ANN ARBOR HISTORIC DISTRICT COMMISSION

Staff Report

ADDRESS: 508 Third Street, Application Number HDC17-029

DISTRICT: Old West Side Historic District

A11

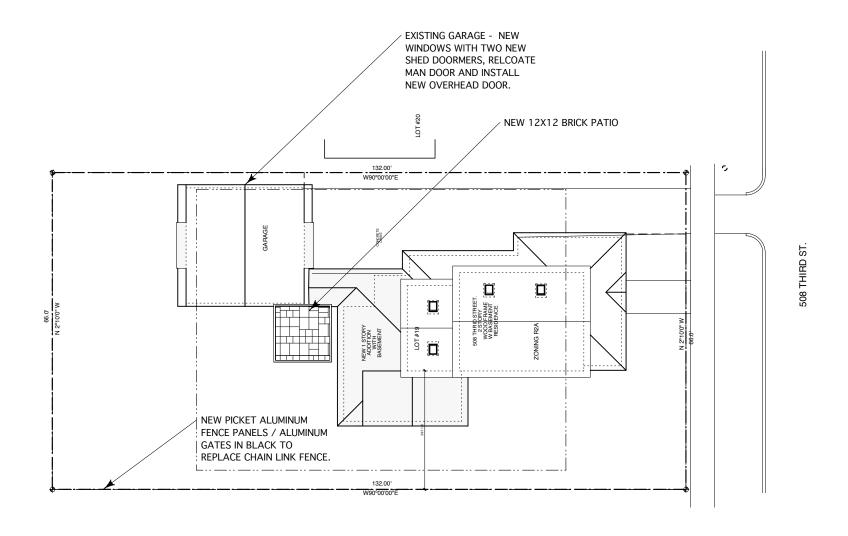
- 9. Drawing A11 shows the new black aluminum picket fence following lot lines except ending at the south side of the driveway. The location is appropriate, but no details are provided about the design or height of the fence.

- Remove the gable from the proposed addition and use a lower roof;
 - Remove the proposed new window in a new opening under the front porch roof: and
 - Provide detail on the fence design and height.
